From: Belton, Moni [moni_belton@fws.gov]
Sent: Thursday, March 14, 2013 5:00 PM
To: Balsam, Briana
Subject: South Texas NRC informal consultation
Attachments: Atch 1 Houston Toad Survey_Requirements.pdf; Atch 3_BMP for river, streams or tributary impacts.pdf; Figure 1 Whooping Crane Corridor.pdf; Atch 2_FWS June_02_2011_letter.pdf

Subject: ER 12-0888, Review of the Generic Draft Environmental Impact Statement (GDEIS) for License Renewal of Nuclear Plants Supplement 48 regarding South Texas, Units 1 and 2.

Figure 1. Whooping Crane Migratory Corridor

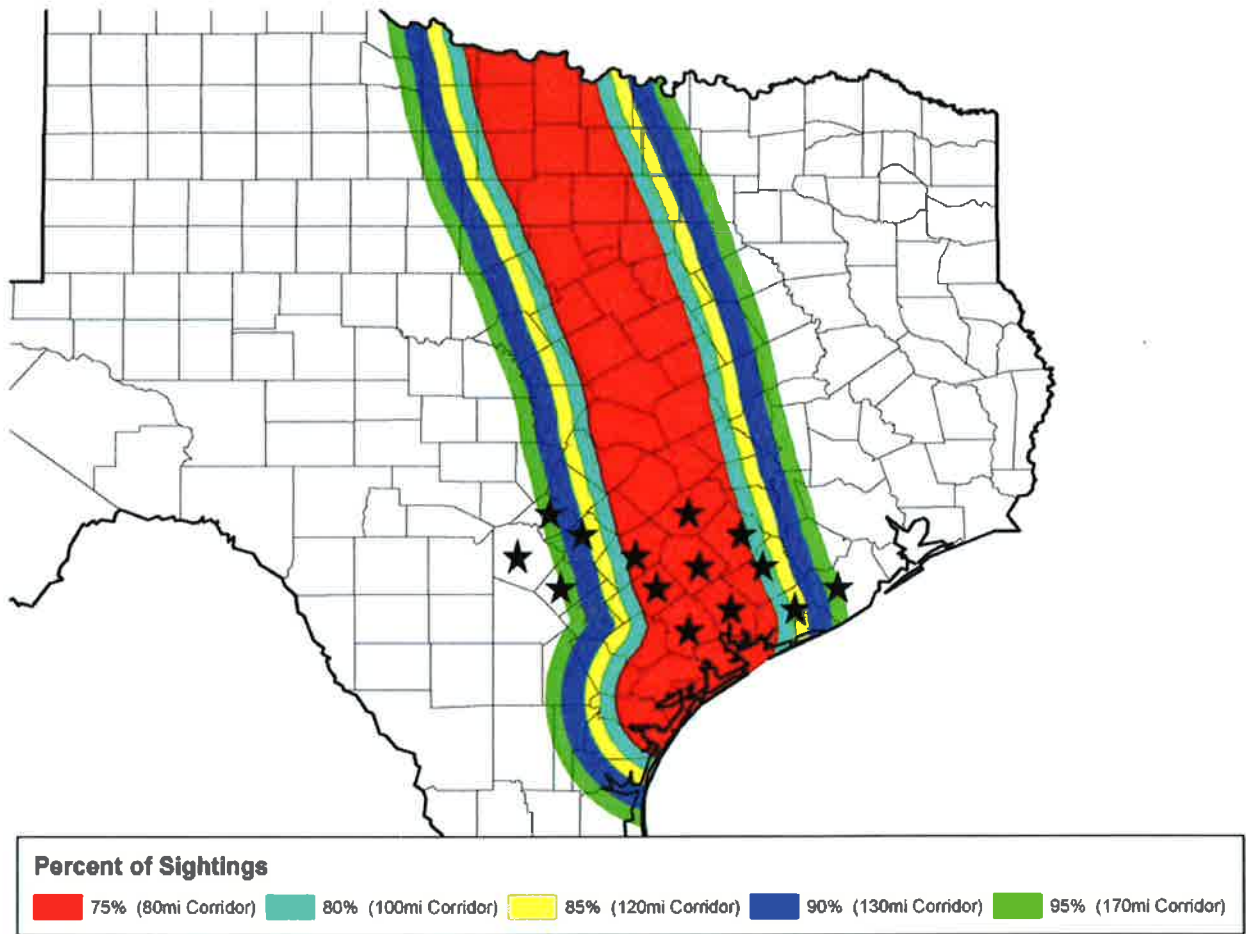
Whooping Crane numbers are increasing and the drought has changed some of their movement. The Cranes are documented in places where they have not historically occurred (example Granger Lake, Williamson County). The Service recommends the below measures be implemented to avoid or minimize potential impacts.

- Schedule work, within the Whooping Crane migration corridor, outside Whooping Crane migrating seasons (normally between March 25 and April 15). See Figure 1, Whooping Crane migration corridor.
 - Consider additional measures, such as adding bird diverters, to reduce impacts along transmission lines.
 - If it is necessary to perform maintenance work during the migrating season biological monitors may be recommended.
 - If using equipment over 15 ft high, lower overnight or mark with diverters.
 - Educate staff on the Whooping Crane, status, identification, and habitats.
 - In any areas where maintenance is being conducted and Whooping Cranes are sited within 1000 feet cease work and notify the Service of the occurrence.
- Please refer to the additional Whooping Crane guidance in the Service's June 2, 2011 letter (attachment 2, Appendix D in the GDEIS).

All 15 counties are within the whooping crane migratory corridor and some are in the critical wintering grounds of the endangered whooping crane (*Grus americana*) (see Figure 1). Whooping cranes use a variety of habitats including marsh, tidal flats, uplands, and barrier islands and roost in waters less than 10 inches. Whooping cranes usually arrive on the Texas coast between late-October and mid-November and spend almost six months on the wintering grounds. As spring approaches, they leave for the breeding grounds in Canada normally between March 25 and April 15 with the last birds usually gone by May 1st (occasional stragglers may stay into mid-May).
